**MONTGOMERY COUNTY HISTORIC PRESERVATION COMMISSION**  
**STAFF REPORT**

<b>Address:</b>	7208 Willow Ave., Takoma Park	<b>Meeting Date:</b>	3/10/2021
<b>Resource:</b>	Contributing Resource <b>Takoma Park Historic District</b>	<b>Report Date:</b>	3/3/2021
<b>Applicant:</b>	Matthew & Lori Steenhoek Ben Norkin, Architect	<b>Public Notice:</b>	2/24/2021
<b>Review:</b>	HAWP	<b>Tax Credit:</b>	n/a
<b>Permit No.:</b>	942402	<b>Staff:</b>	Dan Bruechert
<b>Proposal:</b>	Rear Porch Enclosure

**WILLOW AVE SCREEN PORCH**

**7208 WILLOW AVE  
TAKOMA PARK MD 20912**

SHEET NAME:  
**PROPOSED  
FLOOR PLAN**

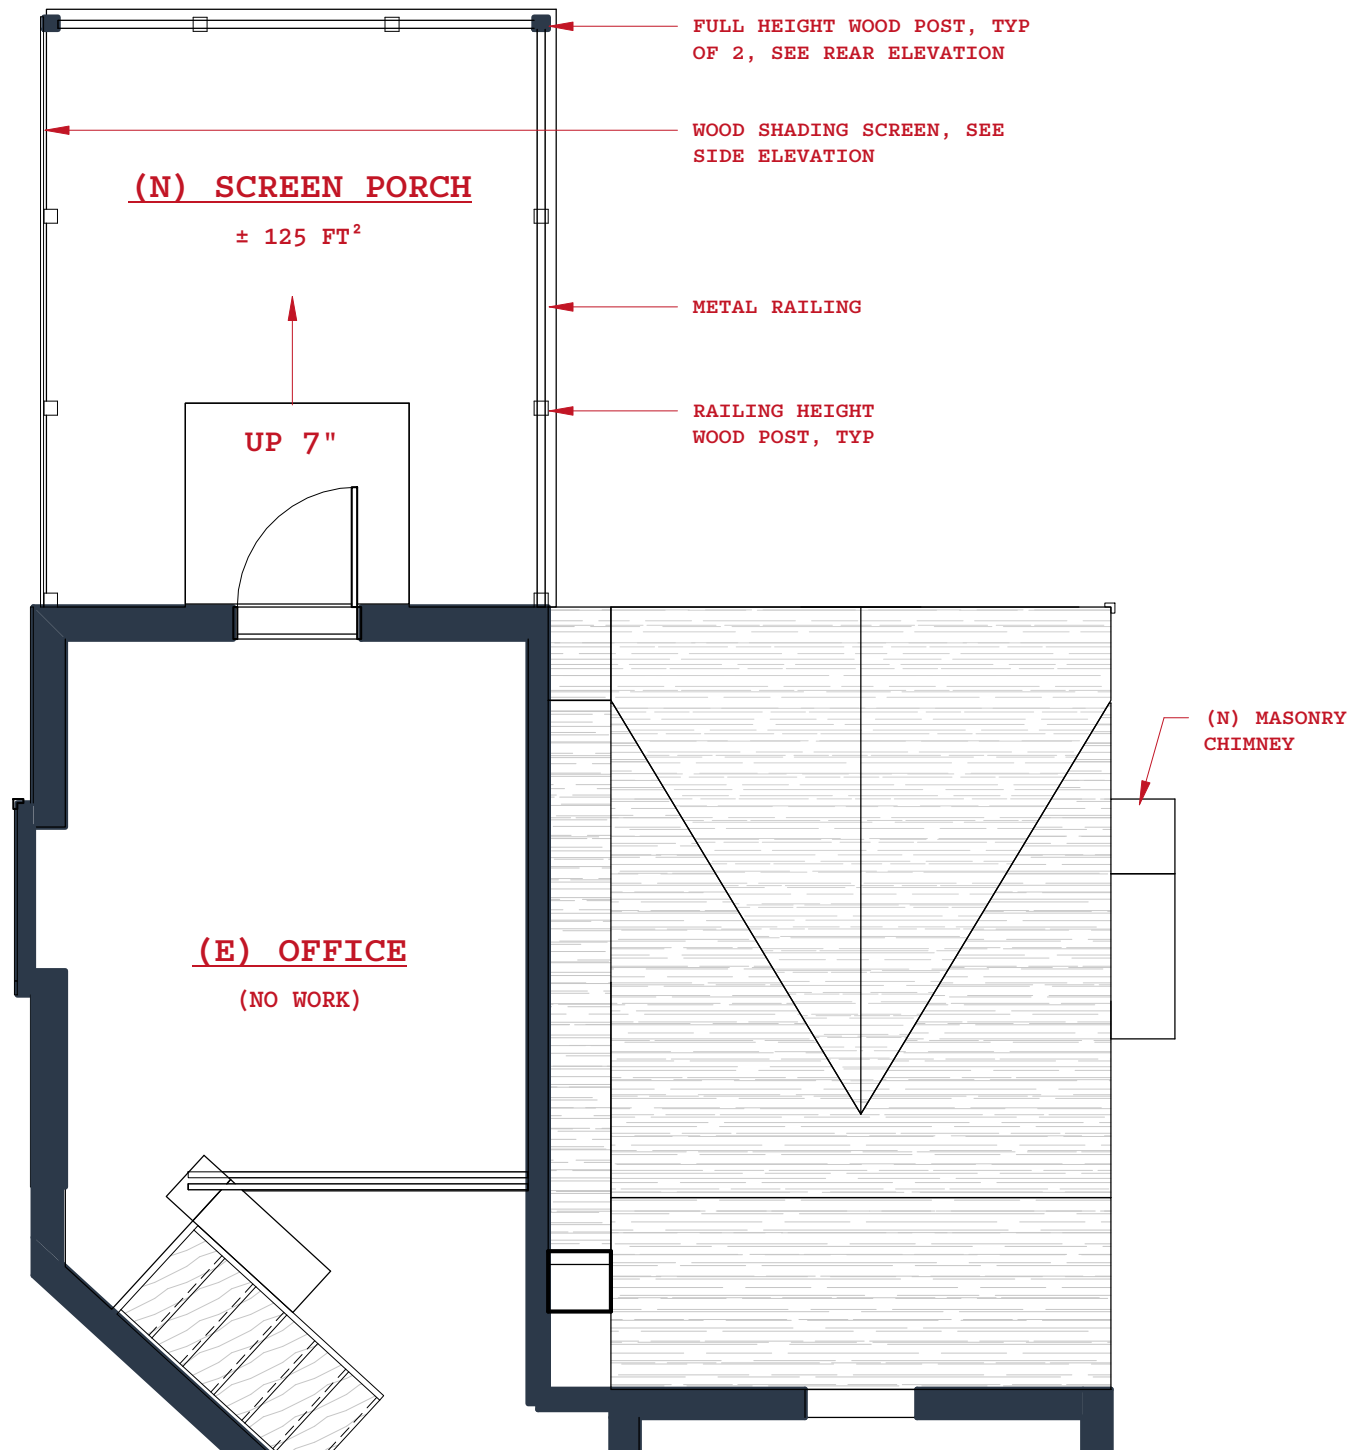
The largest proposed change is the demolition of the existing bay and decorative lattice structure and the construction of the screened-in porch with the deck above. The proposed screened-in porch measures 12' 2 3/4" x 10' 4 3/4" (twelve feet two and three-quarter inches by ten feet four and three-quarter inches). Above the proposed porch, the applicant proposes to construct a deck with a wood frame that continues the outline of the rear gable. The proposed porch and deck will be constructed out of wood with a screen between the posts. On the south elevation, the applicant proposes to construct a wood shade screen constructed out of horizontal wood slats that continue up to the railing of the second-floor deck.

**(EXISTING REAR ELEVATION)**

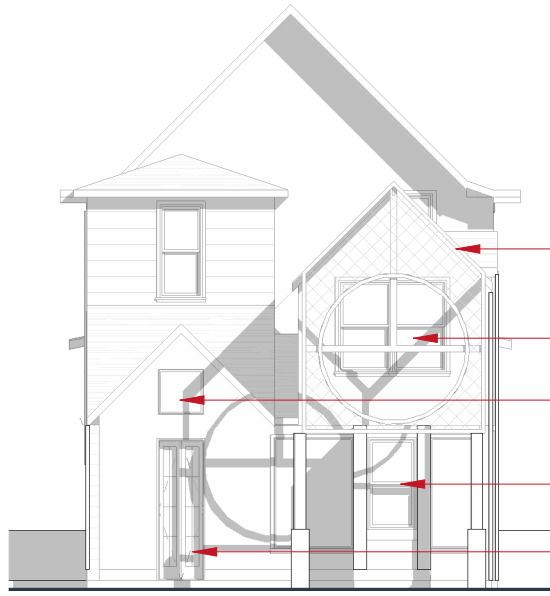
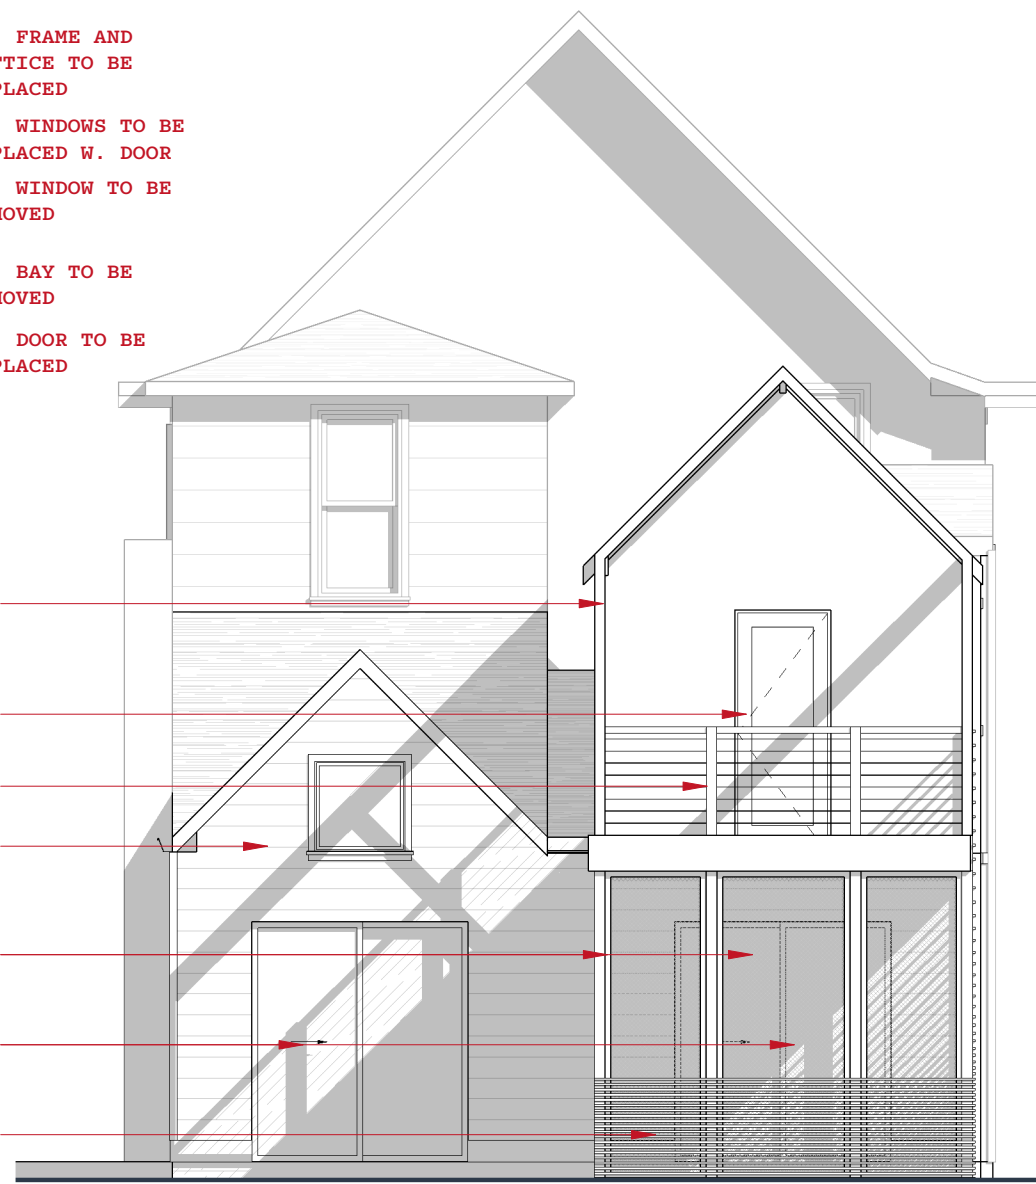
At the rear of the subject property, is a large addition with two rear-facing gables covered in stucco with wood battens. On the first floor, there is a projecting bay with a decorative lattice above. The applicant proposes to remove the first-floor bay, a door, and several non-historic windows from the rear addition. In place of these features, the applicant proposes installing a new aluminum sliding glass door, new wood casement windows, and a new screened-in porch with a deck above. The applicant additionally proposes to remove the wood battens and install new fiber cement clapboards on the rear addition. On the right (north) elevation, the applicant proposes a new masonry chimney. The proposed work will not be at all visible from the public right-of-way.

Staff finds the alterations to the rear addition will not impact the appearance or character of the historic house or surrounding district. Staff additionally finds that the proposed wood casement windows are appropriate for the house. The proposed doors will have a minimal impact on the resource and surrounding district because they are to the rear of the house and should be approved as a matter of course.

Staff finds the proposed porch will not be visible from the public right-of-way, and the *Design Guidelines* state the proposal should be approved as a matter of course. Additionally, Staff finds the location and materials of the proposed porch and deck to be consistent with the character of the house and surrounding district. While the *Design Guidelines* encourage construction that is consistent with the predominant style

of the resource, the *Design Guidelines* also place design review emphasis to changes that are at all visible from the right-of-way. As a feature that is not visible from the right-of-way, with a lenient level of review (per 24A-8(d)), Staff finds this is an appropriate design and recommends the HPC approve the HAWP.
